City of Woodburn
Community Development

Memorandum

Date: October 28, 2021
To: Melissa Gitt, Building Official
Cc: Dago Garcia, P.E., City Engineer
Jeff Bolton, Multi/Tech Engineering
From: Colin Cortes, AICP, CNU-A, Senior Planner *cc.*
Subject: **Building permits 971-21-000806-STR through 826-STR Woodburn Place Apts. Planning Division review**

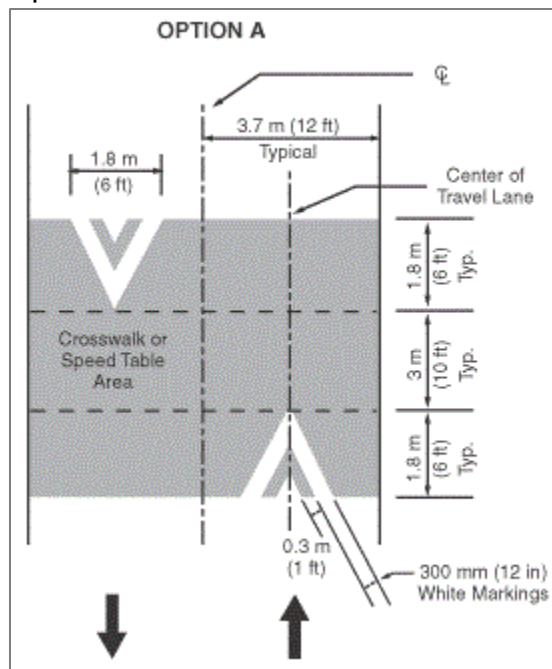
- a. In the context of Condition G4b, staff cannot yet sign off on building permit issuance.
 - b. The planter strip is incorrect. The civil plan Sheet 15 half-street cross section dimensions the frontage planter strip at 6.5 feet, excluding curb width, and the plan view labels it at “6.6””. Condition CU1a requires min width 8 feet, excluding curb width. Revise prior to both civil engineering plans approval by the Oregon Dept. of Transportation (ODOT) and the City, and then construct per the condition.

- c. Street trees are too few. Condition CU1b requires 1 per 30 ft of frontage, equaling 10 trees. Civil plan Sheet 41 illustrates and calls out 3. The condition allows fee in-lieu for max 1 tree, so the developer is to plant at least 6 more trees.

N. CU15: Regarding exterior lighting:

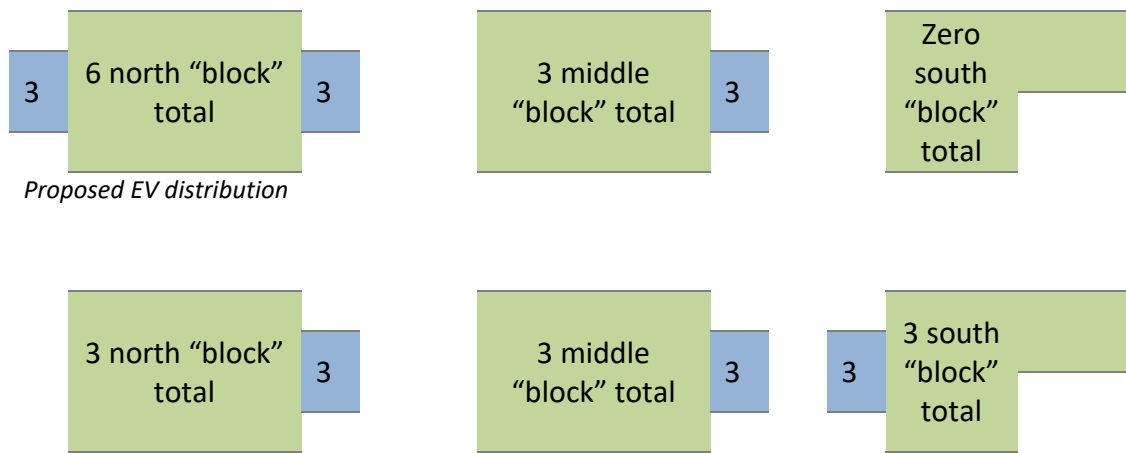
1. Stairwell ceilings: Anticipating that the developer would opt for ceiling lights within apartment building outdoor stairwells, demonstrate conformance with condition part a., e.g., that they are either within and flush with the ceiling or shielded on all four sides.
2. Wall: Sheet C1.3 does indicate wall mount locations, but doesn't indicate the height or heights of them at or below the max per condition part b(1).
3. Other pole: Sheet C1.3 illustrates a "P" pole between the common building and the grove, which the legend indicates is a parking lot pole placement at 14 ft height. However, because per condition part b(2) it's not close enough to parking to be considered a parking pole, it's instead subject to b(3) "other pole" and its height max of 10 ft. Revise accordingly.

Provide illustrations and notes necessary to demonstrate conformance, including cut or spec sheets.

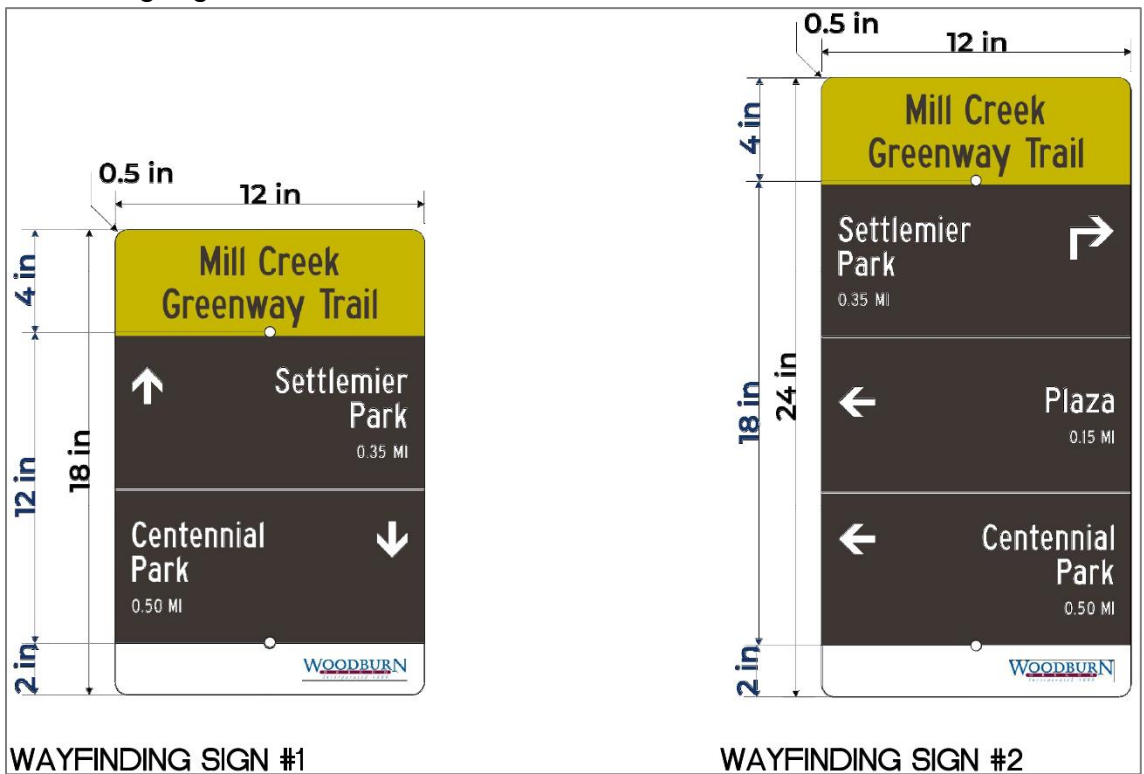
Q. D7: Regarding patio delineations, for all apartment Buildings A-V patios are not delineated

“b. Railings/fencing & gate: The outermost edges of patio concrete slabs that do not abut building walls shall have either metal or wood railings or cedar wood fencing at least 3 ft high. If the latter, then opacity shall be full, but if fencing is higher than the minimum height, it shall be no more than 90% opaque, such as by being fully opaque from grade but from the top having a lattice pattern. The railings or fencing shall have a gated opening at least 2 ft and 4 inches wide.

c. Height maximum: the railings or fencing maximum height shall be either 5 ft or, where a patio faces the access way, 3½ ft.”

(The “access way” is the off-street bicycle/pedestrian path.) Revise as necessary each set of floor plans and elevations. The Sheet C1.3 note about railings/fence lack accompanying detail drawings (elevations and cross section[s]) to demonstrate what and how a contractor is to install and what staff would inspect.

C1.3

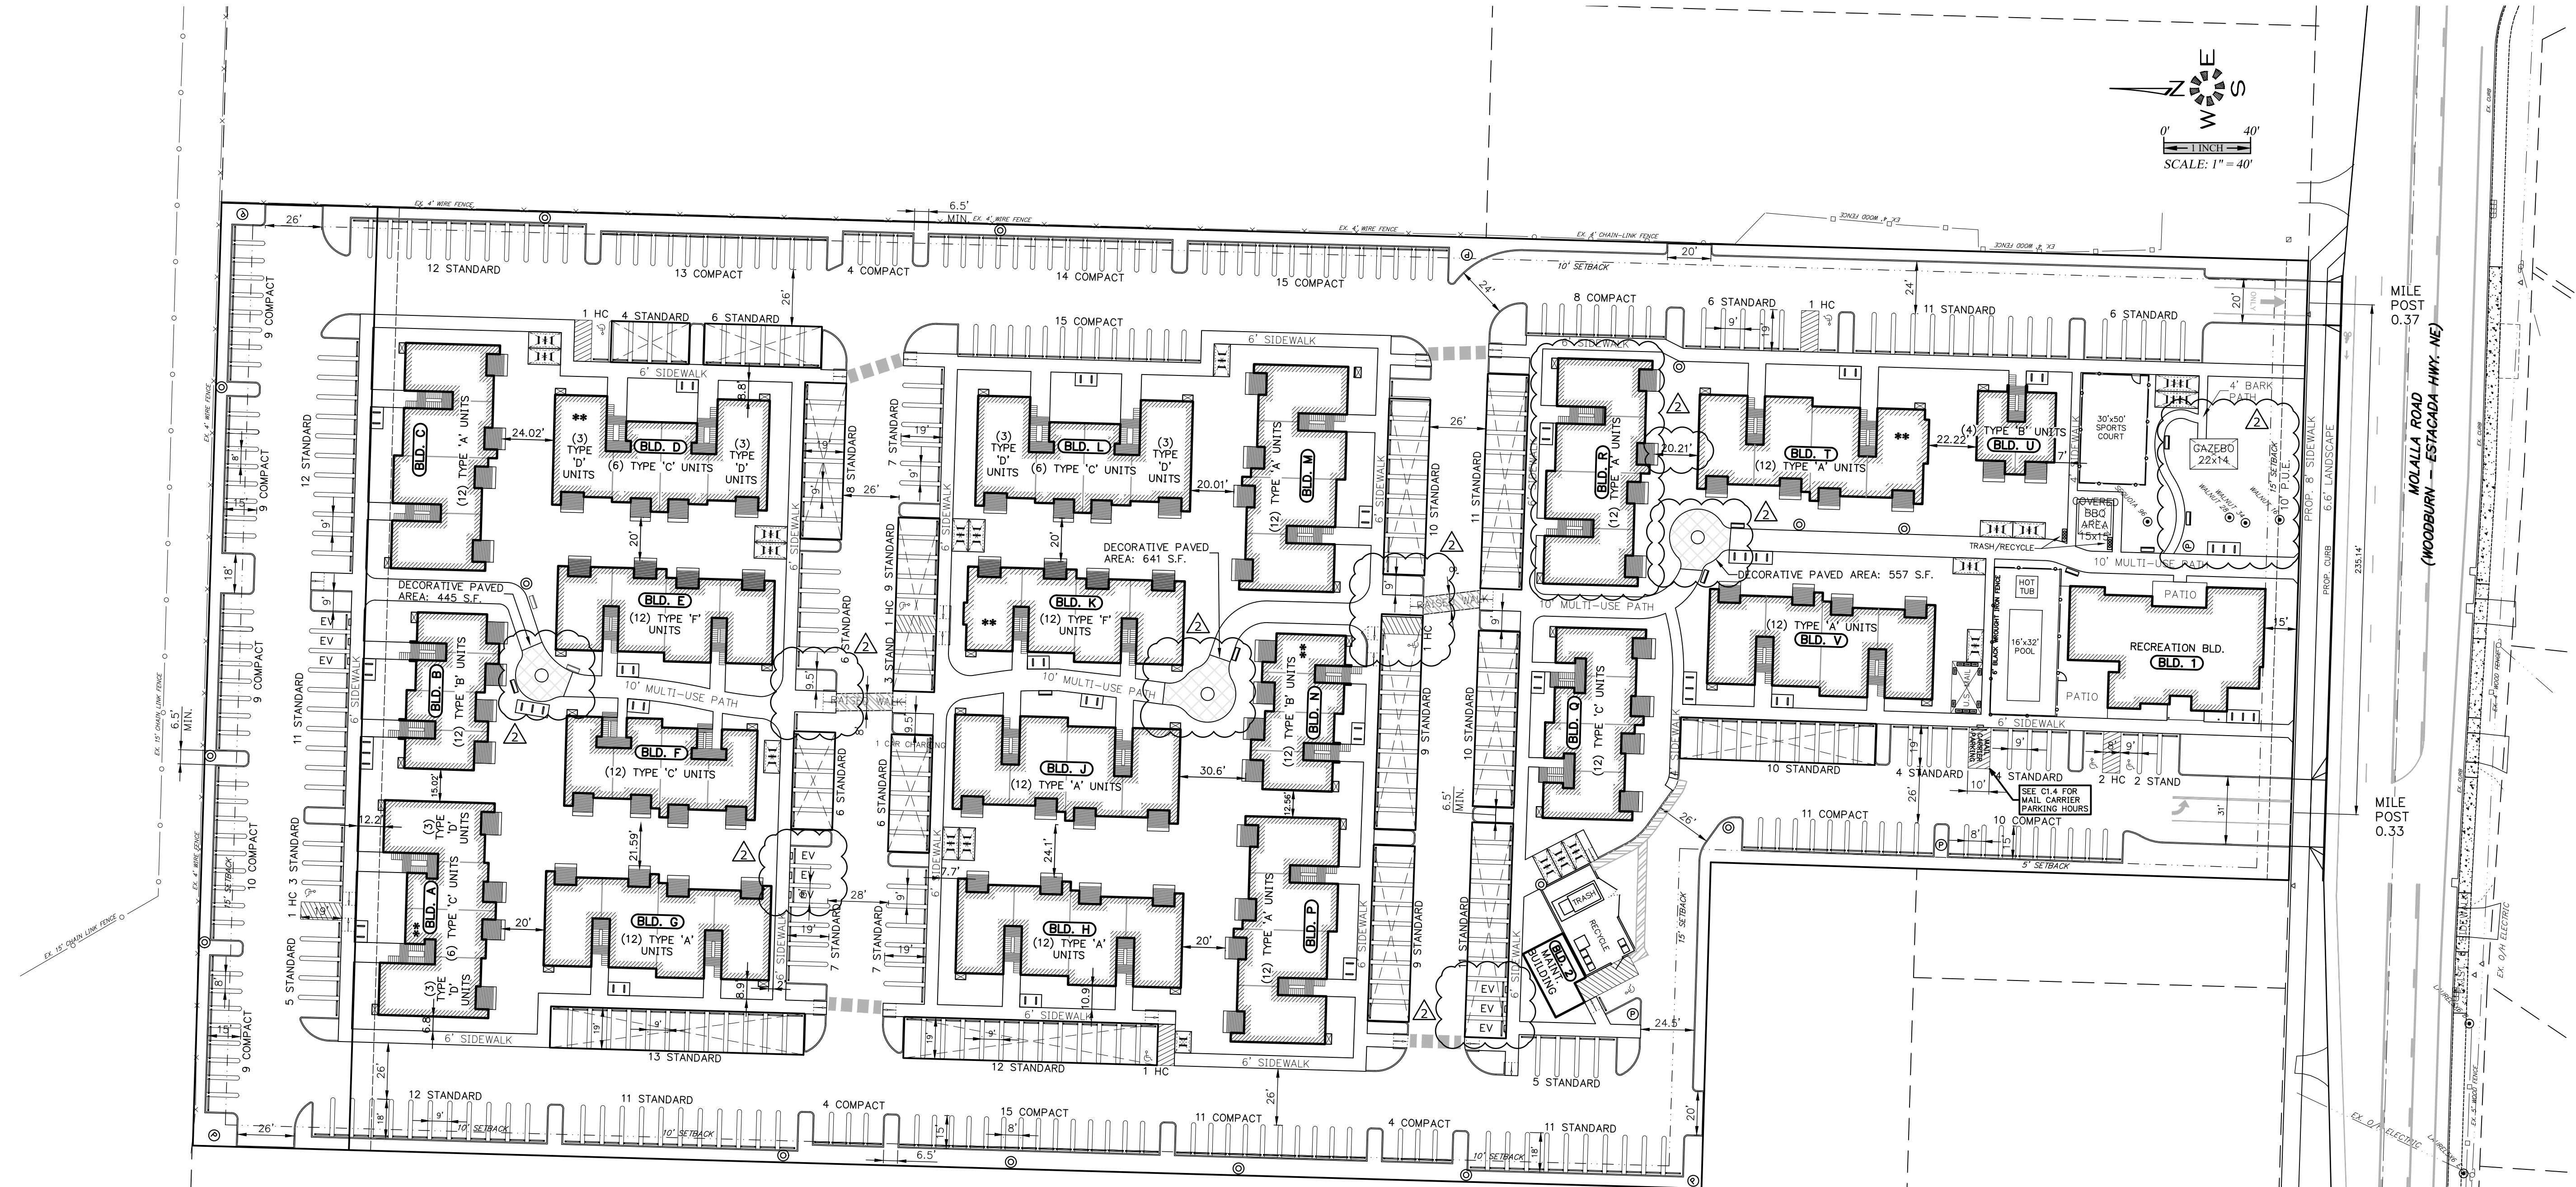
- F. CU4a: Regarding benches and Sheet C1.3, provide 2 more to meet the min of 12. Place 1 min at the common building, such as at or in one of the two common building patios.

- L. CU11: Regarding wheel stop max height, which Sheet C1.3 indicates at max 4” high, demonstrate conformance also through building permit drawings such that demonstration remains when the contractor receives site copies of approved plan sets.
